Product hierarchy no.				Part no.	SBU	Product Type
SBU	PG	PUG	Type			
04	017	004	0000008029	See list with affected part no. in section 8 Appendix	CBE, Circuit Breaker	T9

- Change of product marking

Product Change Notification					PCN T9 Product marking change		
owner	creation date	release date	released by	change order	rev	page	D10-064-837
marbacja	12.04.2022	08.09.2022	schulejo	2024623	A	1 of 2

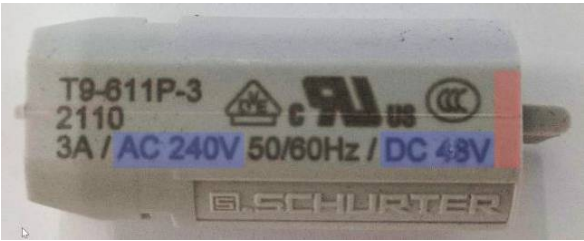
Current product appearance	New product appearance
	 <ul style="list-style-type: none"> <li>■ Changed appearance of voltage rating</li> <li>■ Added CE and UKCA symbol</li> </ul>
